**NH-IM-575-1(33)**

***I-575 Interchange at SR-20***

# **Value Engineering Study Report**

**Preliminary Design**

WALL #4 (AS DESIGNED)

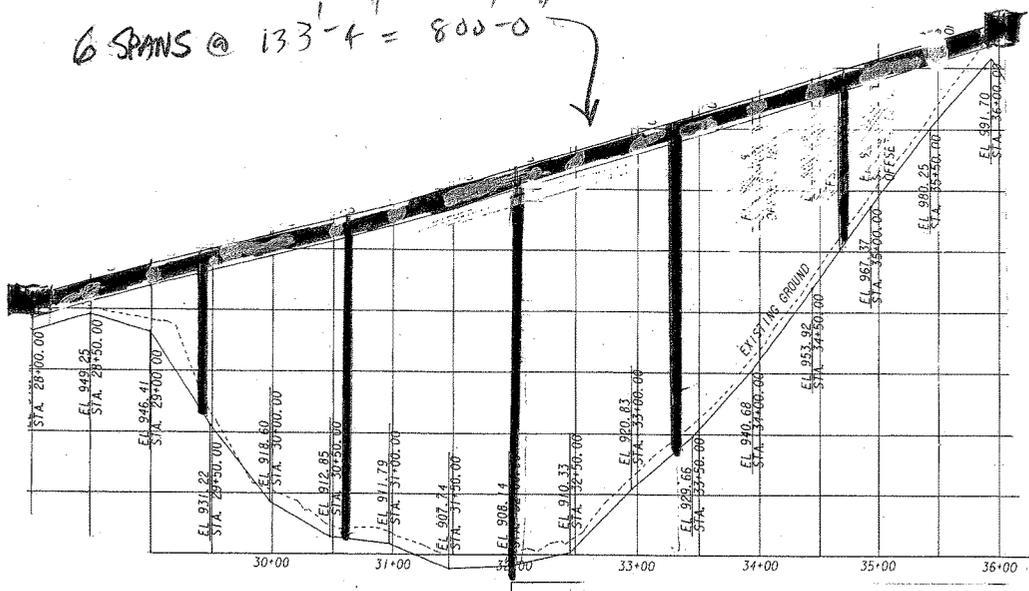
Replace Wall #4 with a bridge of the same length. Use Bulb-T superstructure type as with the proposed Stream #5 bridge.

Replacing the proposed Wall #4 with a bridge of the same length will result in moderate cost savings. The desirability of the alternative lies in the minimal impact of the structure to the site and environment. Using a bridge is also consistent with using a bridge at the end of Ramp "C."

# SKETCHES

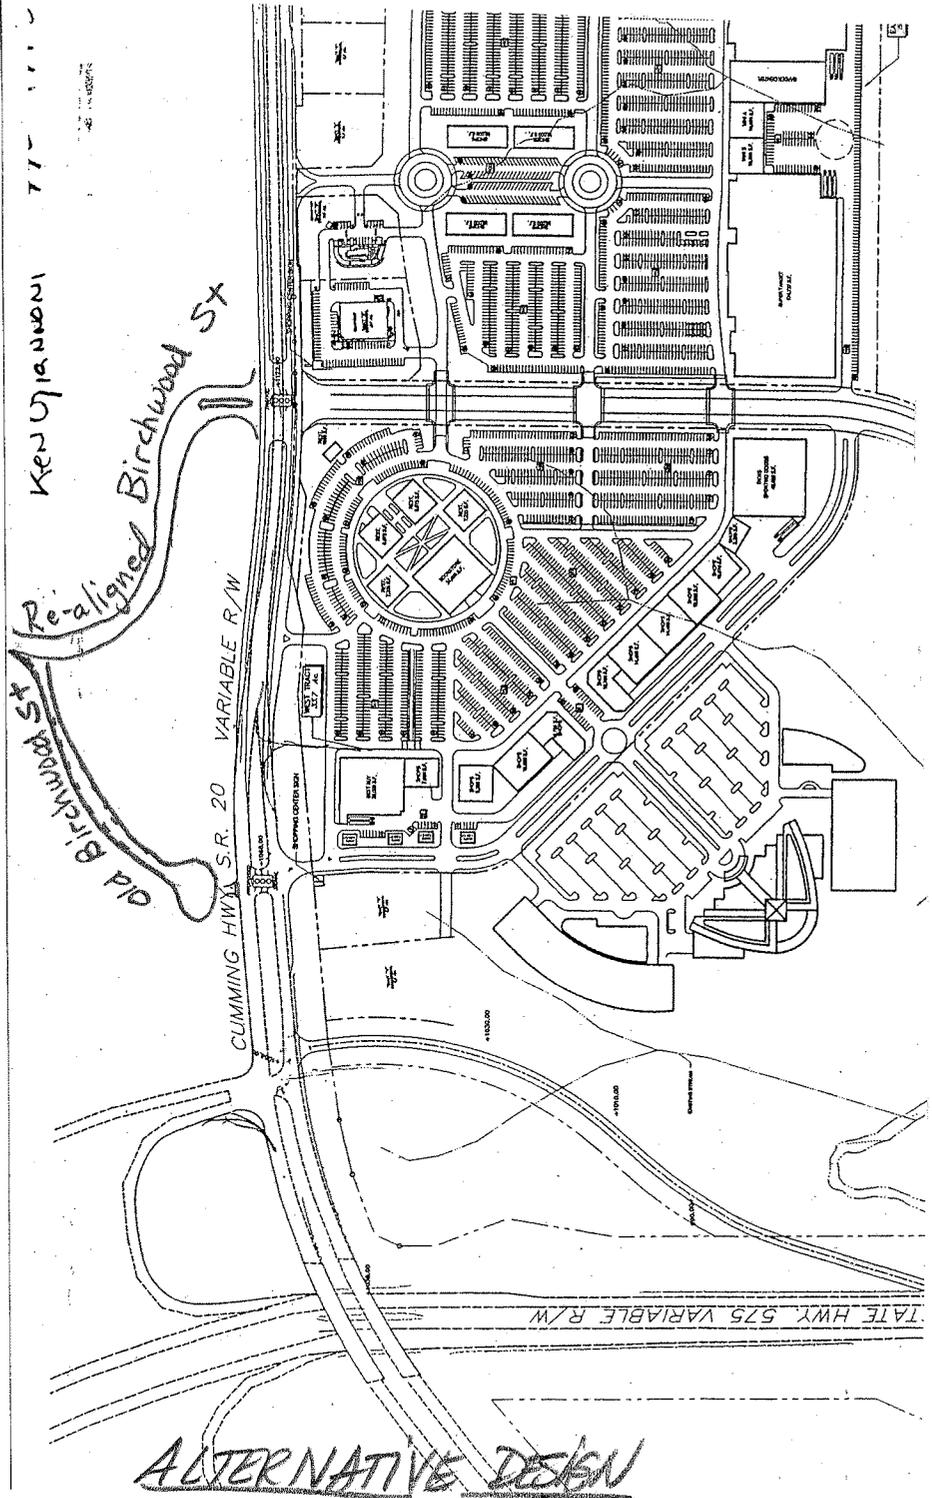
The realignment will reduce existing and future weave conditions. By eliminating the need for a signal at Birchwood St. in the future, the progression of traffic through the interchange will be improved.

ALTERNATIVE NO.: RP-11

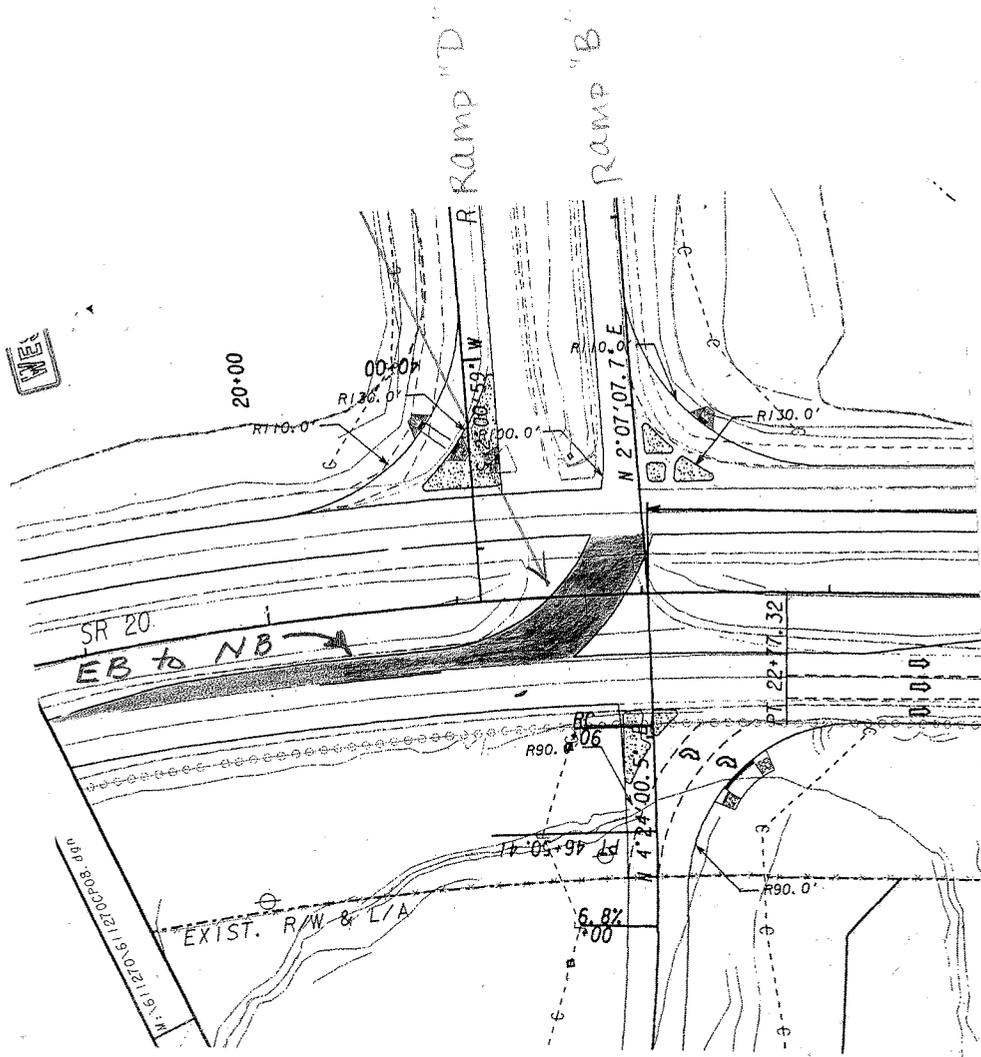
DESCRIPTION: **PROVIDE ADEQUATE TURNING RADIUS AT INTERSECTION #2**

ALTERNATIVE DESIGN INTERSECTION #1,

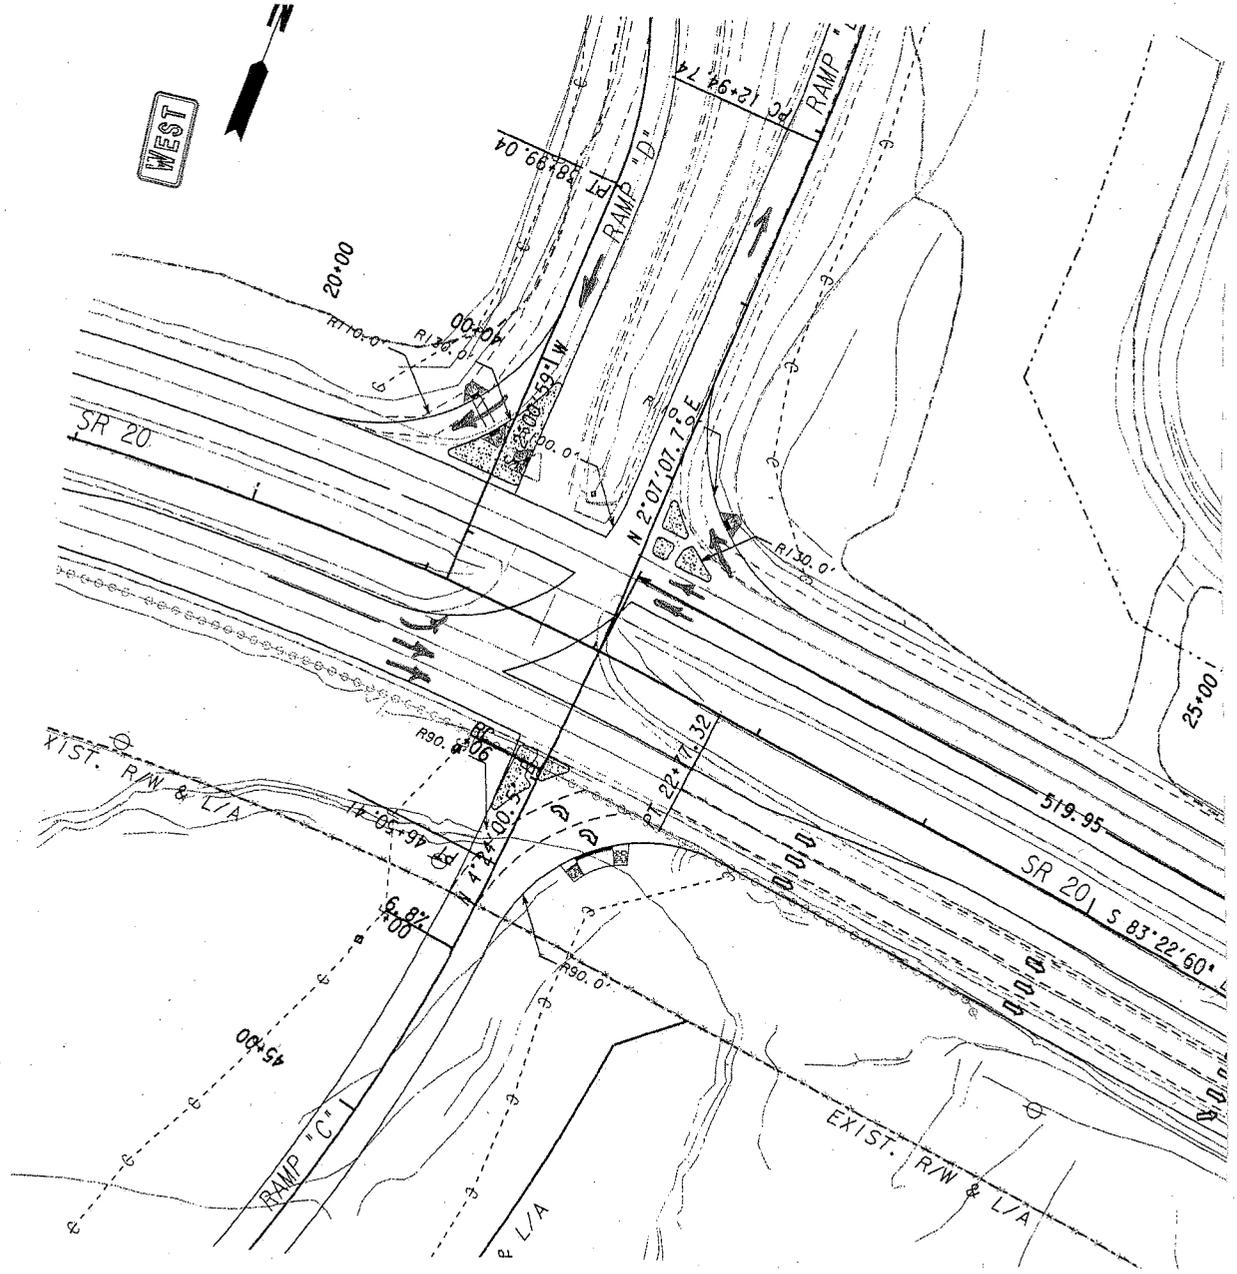
Add third phase to traffic signal to provide protected left turn.

PLAN

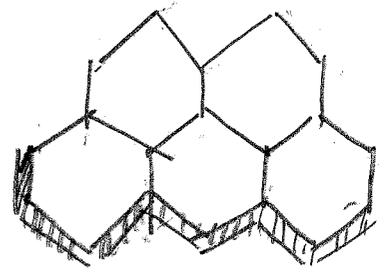
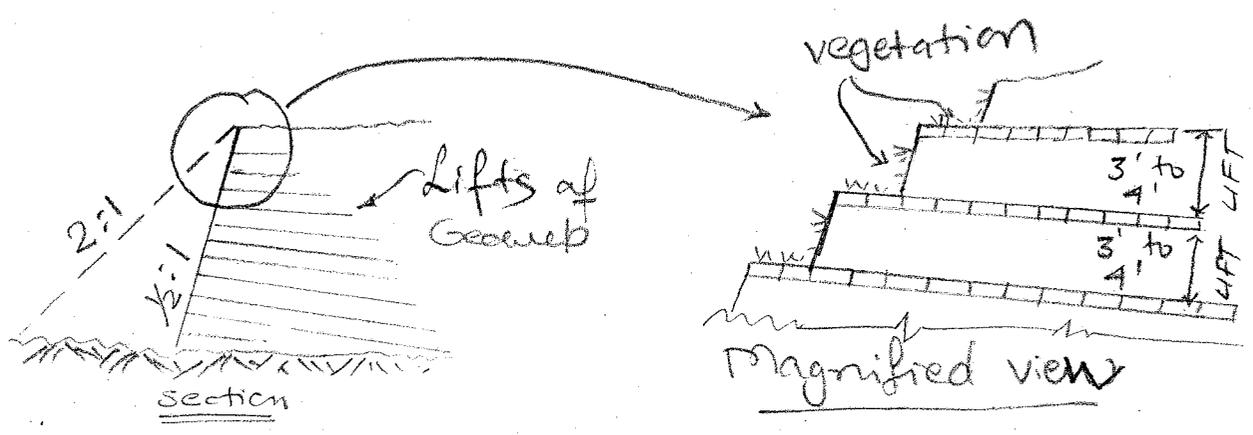
Provide steeper fill slopes with stabilized earth.

The steepened slopes are stabilized by growing grass/vegetation on it through hydroseeding.

Alternative Design: Steepen the slopes by stabilizing the earth with geotextiles and hydroseeding.
